POWER PLANT - ENGINE - EEC FAN HARNESS - INCORPORATE ADDITIONAL SPACERS ONTO CLIPPING
POINTS CP1022 AND CP1017 - CATEGORY CODE 3 - MOD.ENG-71-0048

V2500-ENG-71-0048

SERVICE BULLETIN

View on right-side of the fan case
Fig.1

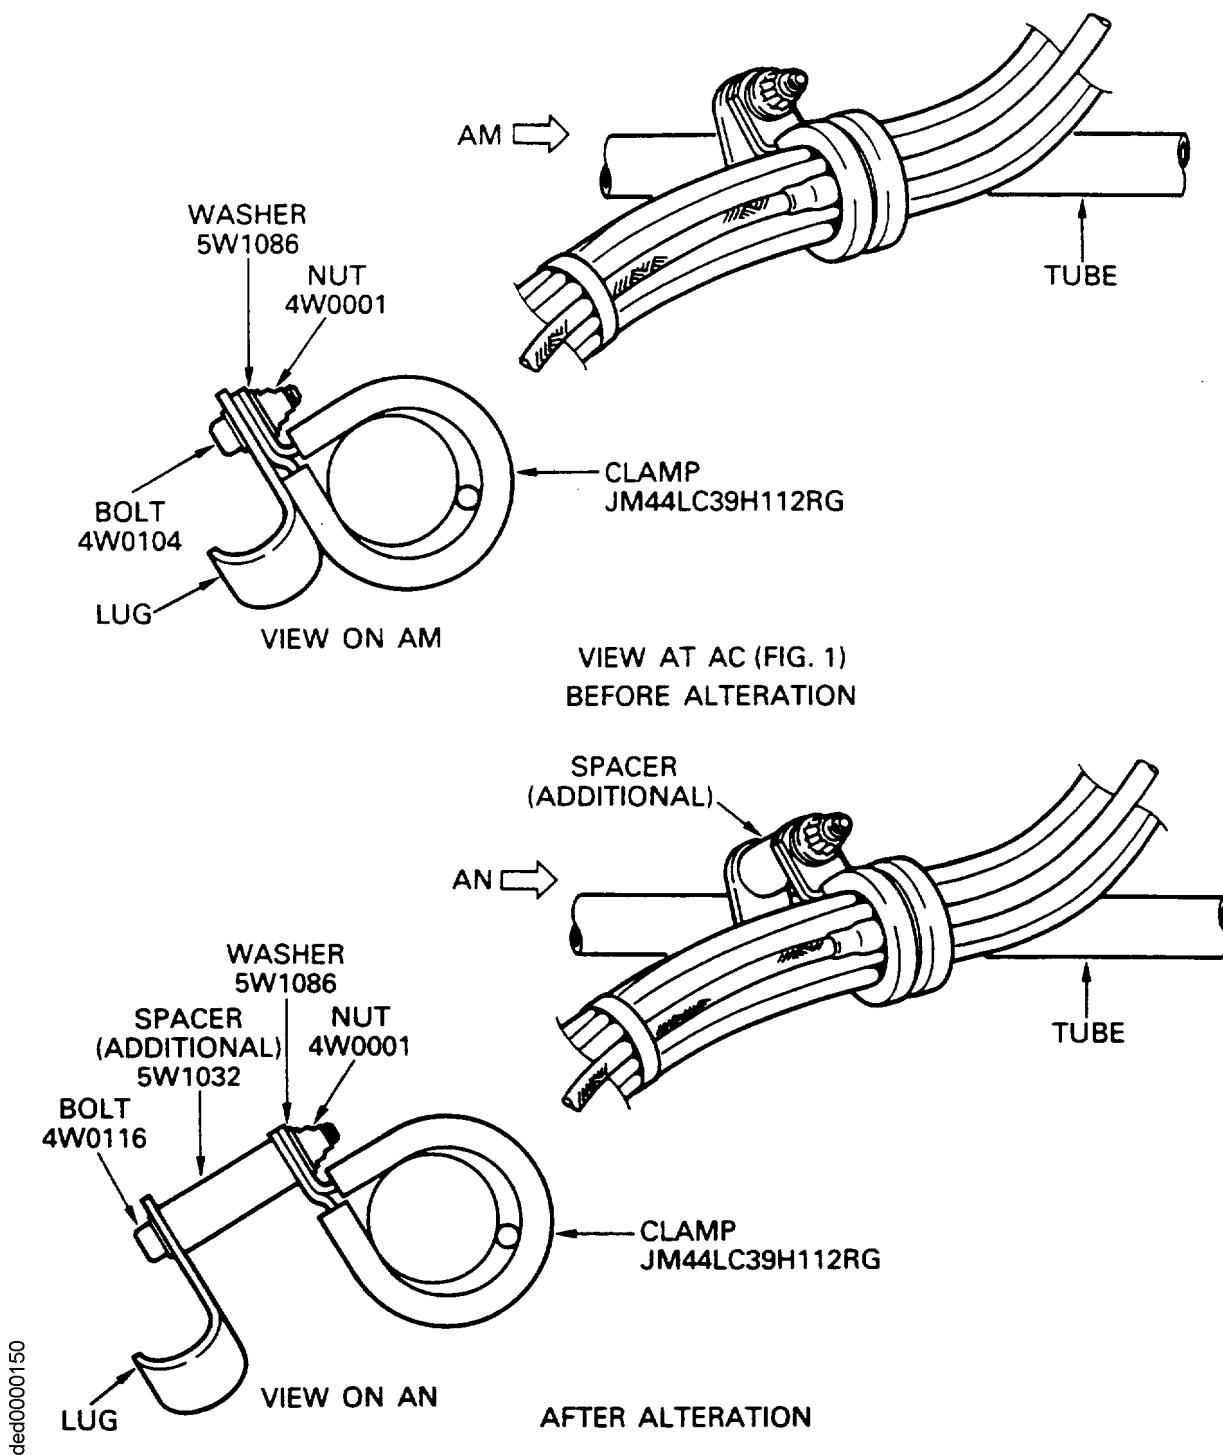
There is little clearance between the EEC Fan Harness and the Turbine Cooling Controlled Air Tube (Ref. 75-23-48, 01-500) near the top corner of the ACOC. Chafing may occur between them. (Refer to Figure 1.)

Due to this revision, the clearance between the bolt end and the tube was improved, but the clearance between the Tube and the EEC Fan Harness near the top corner of the ACOC, was reduced. The possibility of chafing remains between them. (Refer to Figure 1.)

To give additional clearance between the EEC Fan Harness and Turbine Cooling Controlled Air Tube.

| (1) Find the clipping points CP1017 and CP1022. | Refer to Figure 1. |

. Details of the clipping point CP1017 - Before and after alteration
Fig 2

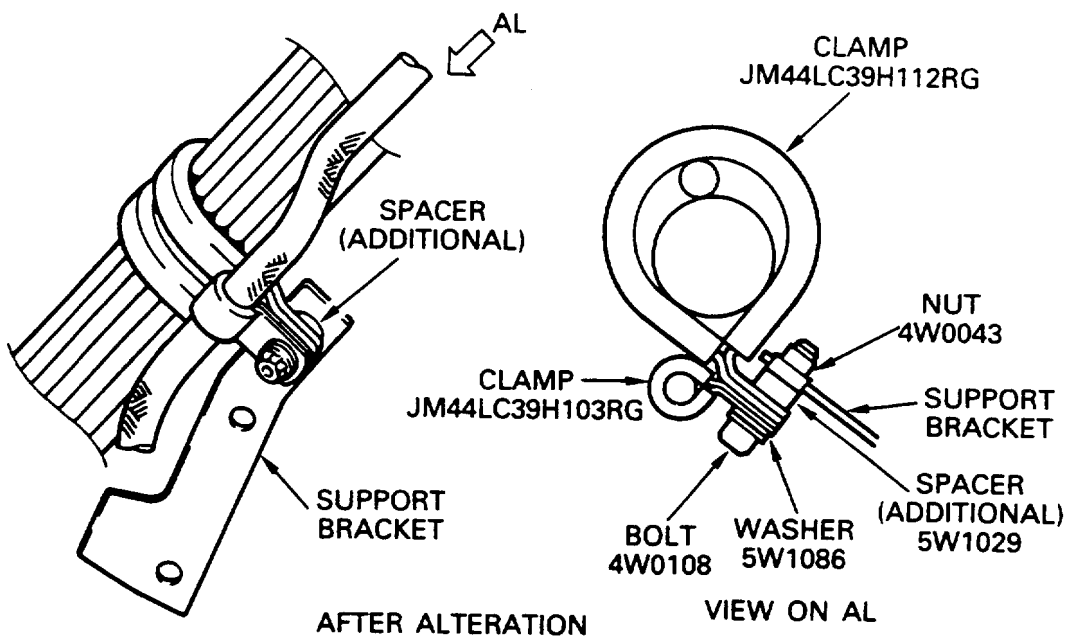
- (a) Additional spacers are introduced into EEC fan harness clipping points CP1022 and CP1017. The clipping point CP1022 are separated from the support bracket on the ACOC with a 0.1969in. (5,00 mm) long spacer. (Refer to Figure 3.) The clipping point CP1017 are separated from the lug on the tube with a 0.7480in. (20,00 mm) long spacer. (Refer to Figure 2.)
- (b) The resultant clearance between the EEC Fan Harness and the Turbine Cooling Controlled Air Tube (Ref. 75-23-48, 01-500) is approximately 0.3937in. (10,00 mm).

| (2) Remove the PN 4W0001 nut, the PN 5W1086 washer and the PN4W0104 bolt from the clipping point CP1017. | Refer to Figure 2. |
| (5) Install the new PN 5W1032 spacer to the clipping point CP1017 with the PN 4W0001 nut, the PN 5W1086 washer and the PN 4W0116 bolt. Torque the bolt to 100 lbfin (1,13 mdaN). | Refer to Figure 2.
